Title: Torque / Washer Check L/H Lower Engine Mount Rotax 915 iS		
AG-SB-2023-04-B-EN	Effective Date: 09.10.2023	Compliance Category:
Applicability		A – MANDATORY B – RECOMMENDED C – OPTIONAL
Aircraft type & model: All aircraft with a Rotax 915 iS engine and a fixed nut on the left lower engine mount	Affected Serial number(s): All aircraft	
The maintenance manual to be referenced is this stated or subsequent issue.		As per AutoGyro website
This form is the response from AutoGyro GmbH either against a problem found in the product in service requiring a containment or rectification action, or as service information for aircraft modification incorporation. For help, contact airworthiness@auto-gyro.com.

Bolt with Nord-Lock washer

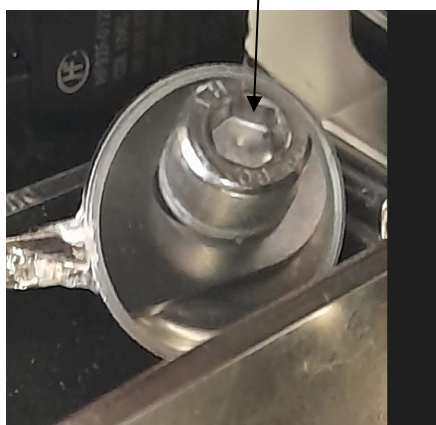
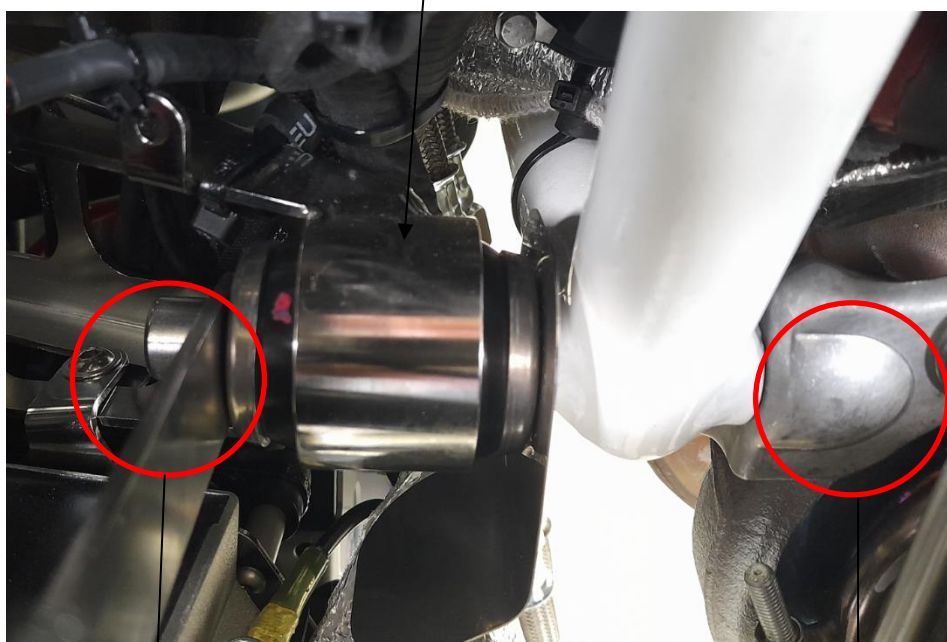
Rotax has factory fitted a nut to the turbocharger plate. AutoGyro now use Nord-Lock washer (PN 48272) in combination with this nut. This washer is only required for Rotax 915 iS engines with a fixed nut. Otherwise, the all-metal nut is used as before. Observe modified tightening torque 56 Nm.

If the aircraft is fitted with a Rotax 915 iS engine fitted with a welded nut on the lower left hand engine mount in the direction of flight you have to check if the Nord-Lock washer has been installed.

If the aircraft is NOT fitted with a Nord-Lock washer on the lower left hand engine mount, carefully loosen the nut and remove the bolt. Support the engine with a crane or similar if necessary. Install the Nord-Lock washer (convex side facing bolt head) and put the bolt back in, release the engine from the crane if this has been done and torque the bolt with 56Nm.
